Supplementary Report to Sydney Central City Planning Panel

Panel reference	2017SWC050
DA number	SPP-17-00005
Proposed development	Demolition and alterations and additions to an existing residential aged care facility
Street address	56 Elsom Street, Kings Langley
Applicant/owner	Adventist Aged Care
Date of DA lodgement	23 March 2017
Number of submissions	6 (including 1 confidential submission)
Regional development criteria (Schedule 4A of the EP&A Act)	Capital investment value (CIV) over \$20 million (DA has CIV of \$23.5 million)
All relevant s79C(1)(a) matters	<ul style="list-style-type: none"> • State Environmental Planning Policy (State and Regional Development) 2011 • State Environmental Planning Policy (Infrastructure) 2007 • Sydney Regional Environmental Plan No. 20 – Hawkesbury-Nepean River • State Environmental Planning Policy No. 55 – Remediation of Land • State Environmental Planning Policy (Building Sustainability Index: BASIX) 2004 • State Environmental Planning Policy (Housing for Seniors or People with a Disability) 2004 • Central City District Plan 2017 • Blacktown Local Environmental Plan 2015 • Blacktown Development Control Plan 2015

Figure 7 –T69 showing structural issues including decay and historic limb failures.

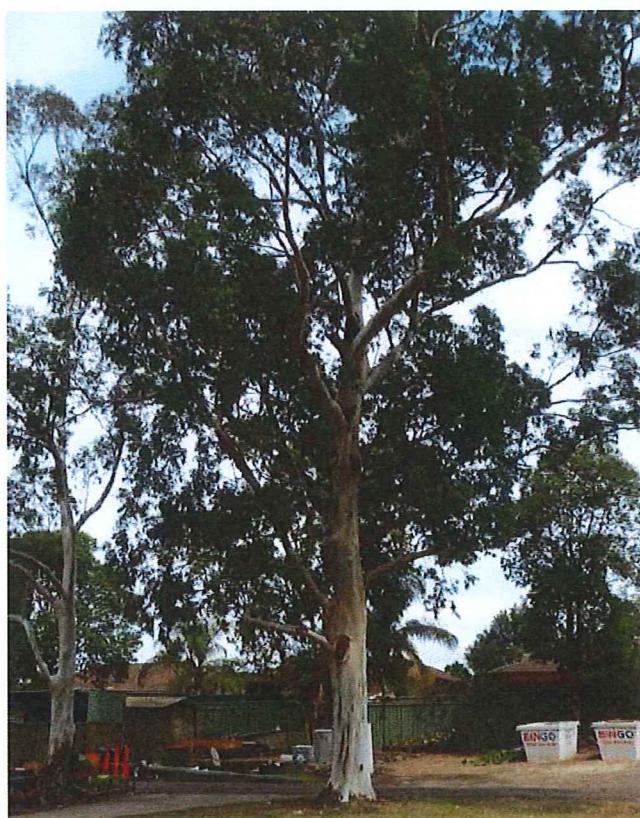
T69, although currently displaying good vitality, is a large Sydney Blue Gum with significant cavities and defects at 8.5 m, 11 m and 12 m height. There is also a history of previous significant branch failures throughout the tree canopy. It has significant structural weakness within the major body of the trunk due to the extensive cockatoo damage and subsequent decay at most of the major branch junctions. Although the tree has compensated, to various degrees, for these weaknesses, by putting on additional wood around the cavities there are still very major structural deficiencies within this tree that cannot be realistically rectified or catered for in site planning. In our opinion this tree would represent too great a risk if left in close proximity to underlying residences or within actively used roadways or car parking areas. In its current condition it is also unlikely to tolerate any significant disturbance around its base. It is extremely likely to continue to periodically shed very sizeable branches from its canopy. In the author's opinion, there is a very significant risk that major parts of the upper canopy of this tree could fail in a moderate storm or wind event.

Both T68 and T69 are, in the author's opinion, unsuitable to be retained within the context of an aged care development and are recommended for removal.

h. Therefore trees T68 and T69 are considered not worthy of retention and should be removed regardless of this development.

k. The arboriculturalist in our Open Space Maintenance section has reviewed the submissions from the applicant’s arborist and concurs with the findings of the report. Trees T68 and T69 are justified for removal as per the submissions and Trees T60, T104, T105 and T106 should be retained and protected.
